CHANGE ORDER NO.: 1

Owner:	Town of Landis	Owner's Project No.:	SRP-D-ARP-0201/25-05
Engineer:	Municipal Engineering, Inc.	Engineer's Project No.:	G22124
Contractor:	Maguire Iron, Inc.	Contractor's Project No.:	
Project:	100,000-gallon Elevated Water Tank		
Contract Name:	100,000-gallon Elevated Water Tank		
	Effective Date of Change		
Date Issued:	25 July 2025	Order:	25 July 2025

Description: **Adding a tubular corral on top of the water tower for a safety enclosure and potential future antenna mounts.**

PROJECT NAME: LANDIS, NC			
DRAWING NAME: ROOF ORIENTATION & 12' ROOF HANDRAIL			
SIZE: 100MC	DATE: 9/20/25	DWG NO. 0	REV: 0
SCALE: VARIES	AUTHOR: DRS	SHEET: 100-20

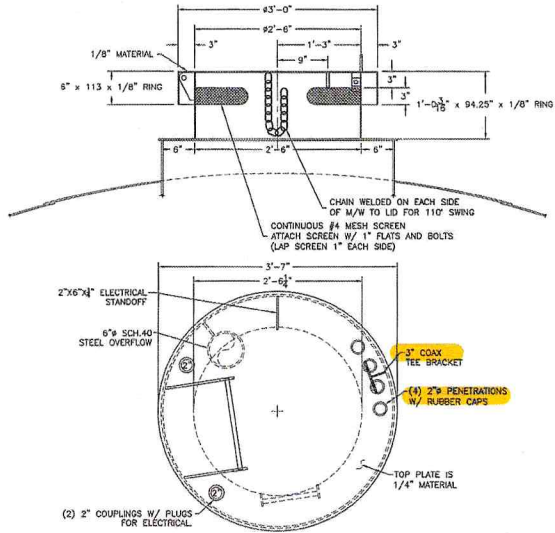
12' TUDULAR ROOF HANDRAIL

ALL PIPE IS 1 1/2" SCH 40
 TOTAL WEIGHT = 600 LBS FINISHED
 SHOP FAB AND SHIP IN PALLET
